To: Prospective Bidders  
From: Wold Architects and Engineers  
Date: July 30, 2014  
Comm. No: 133024

Subject: **Addendum No. 3** for Bidding Documents for the: **Courthouse Renovations Phase I & II**

This addendum forms a part of the Contract Documents dated July 3, 2014. Acknowledge receipt of this Addendum on the space provided on the Bid Form. Failure to do so may result in disqualification of Bid.

### 1. SHEET A0.10 – PHASING PLAN

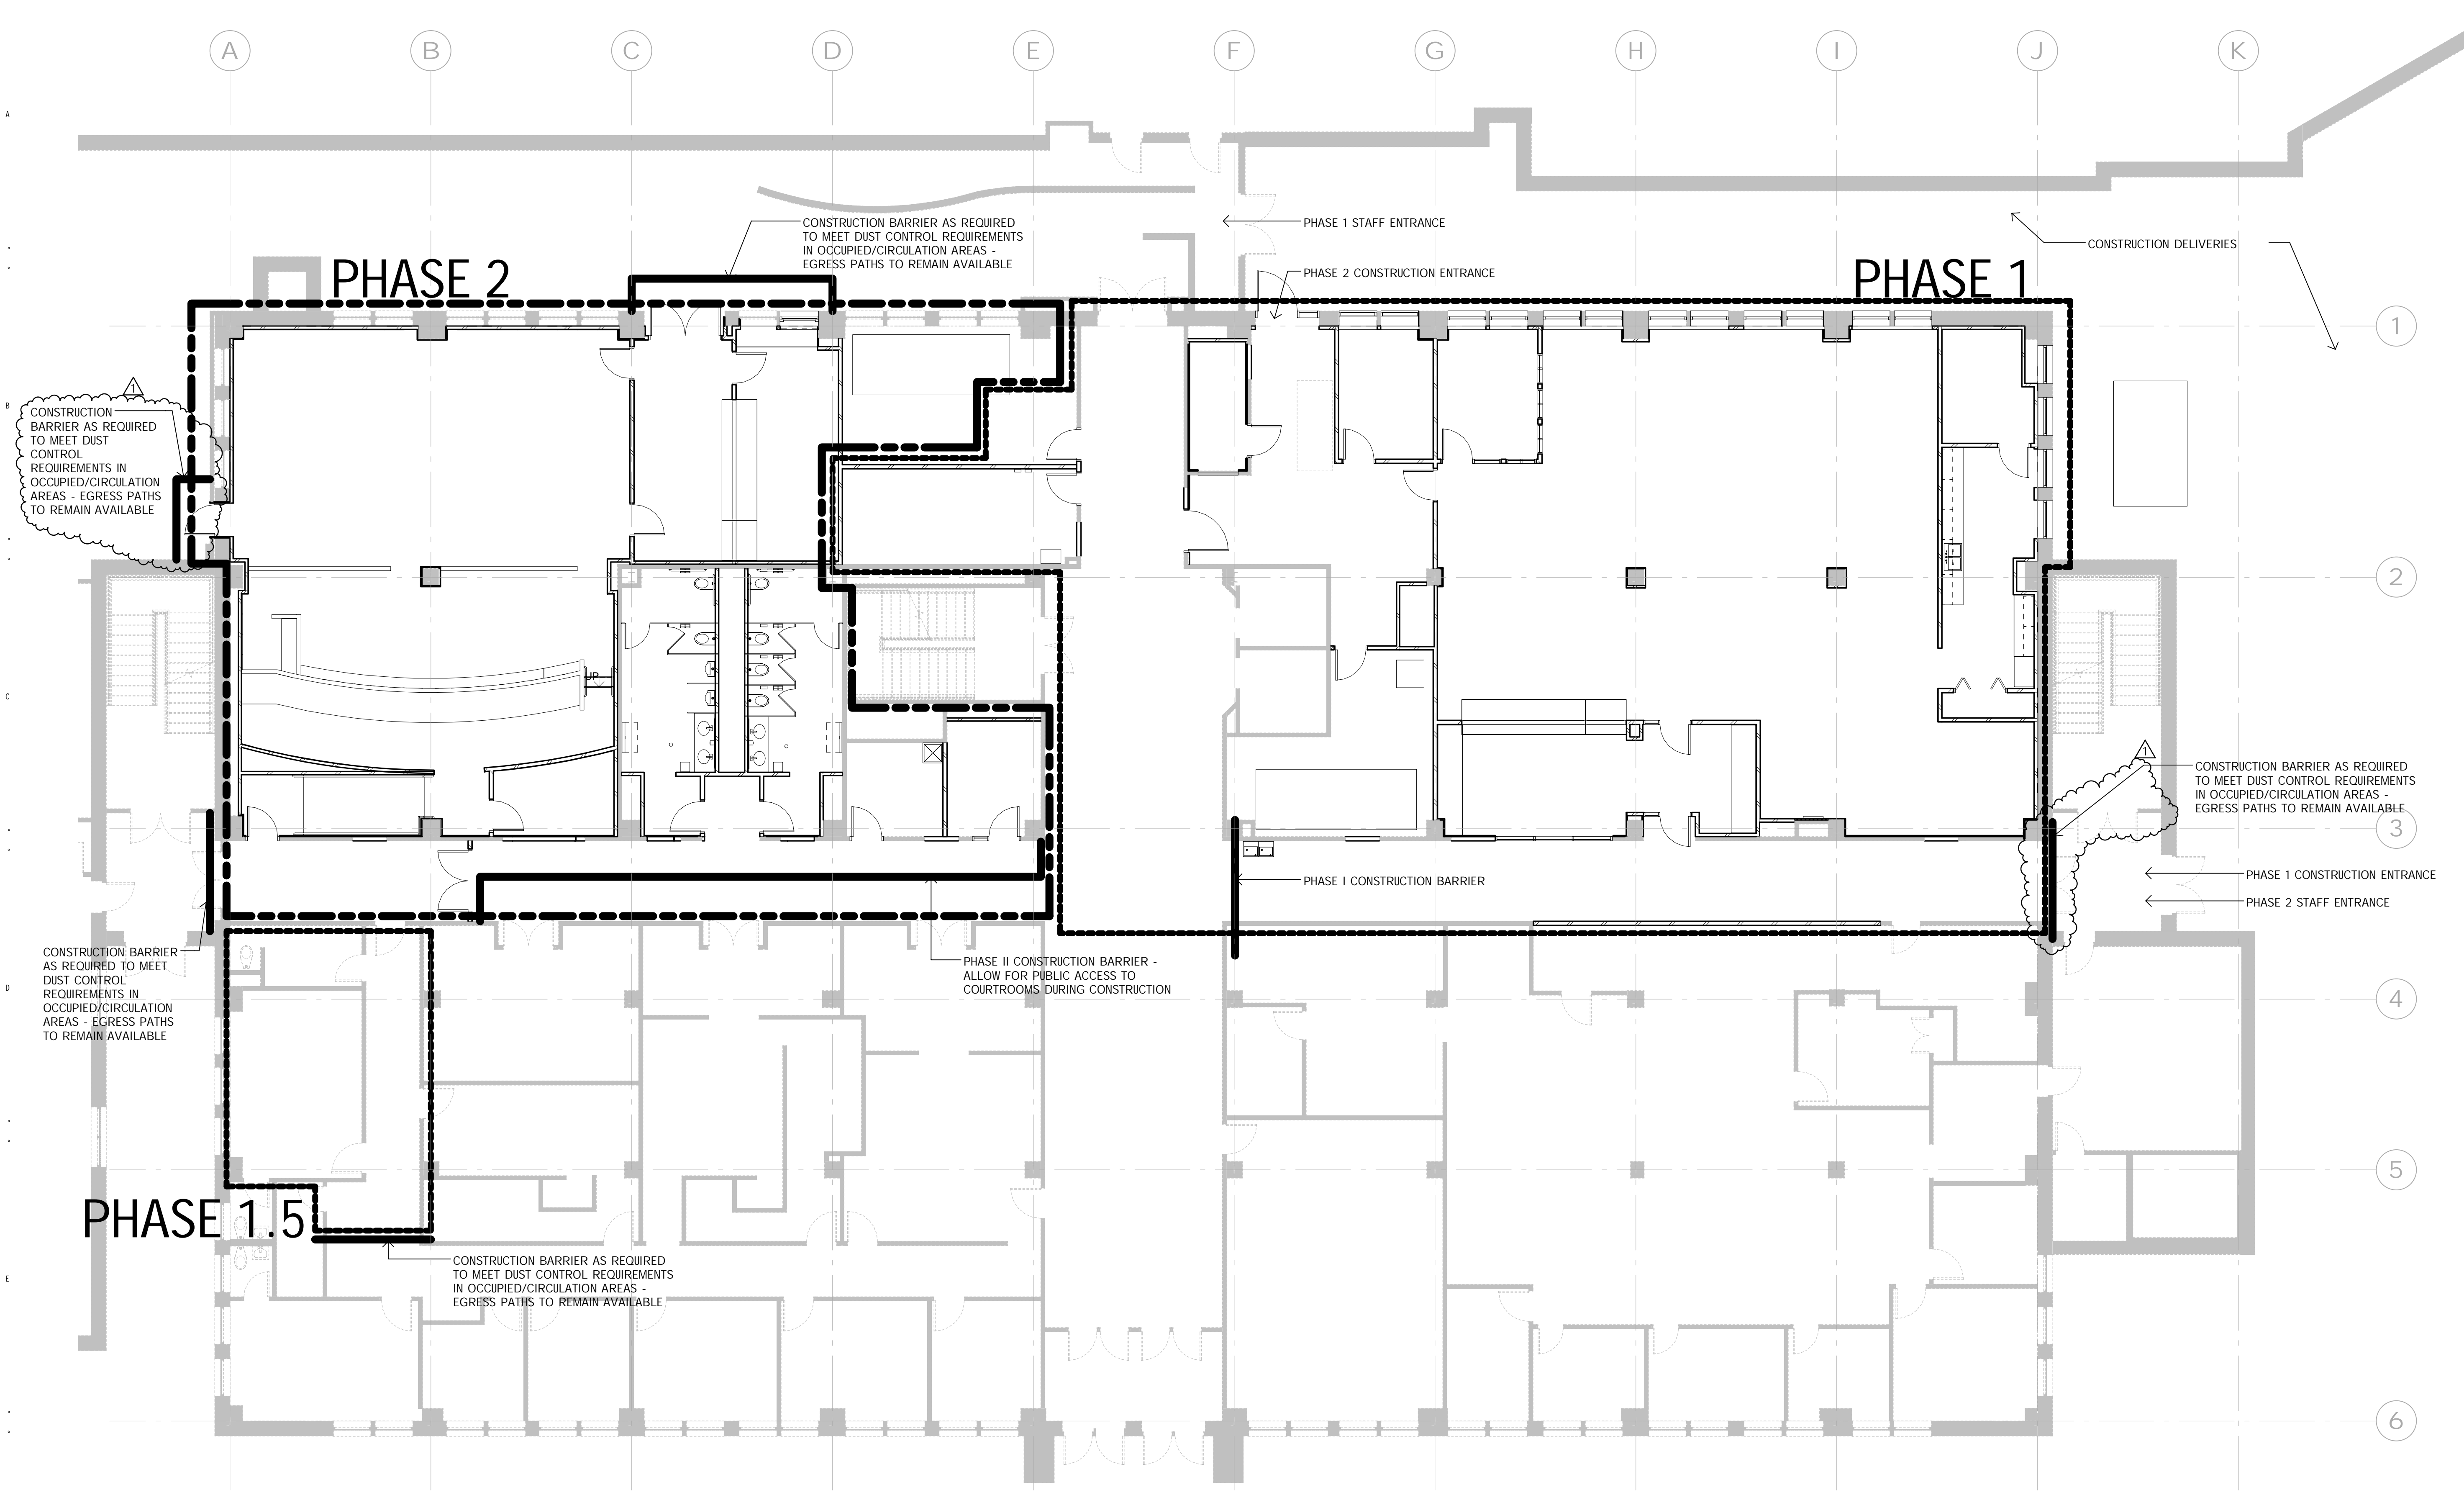
A. Refer to attached Sheet A0.10 for revised Phasing Plan General Notes and Phasing Schedule dates.
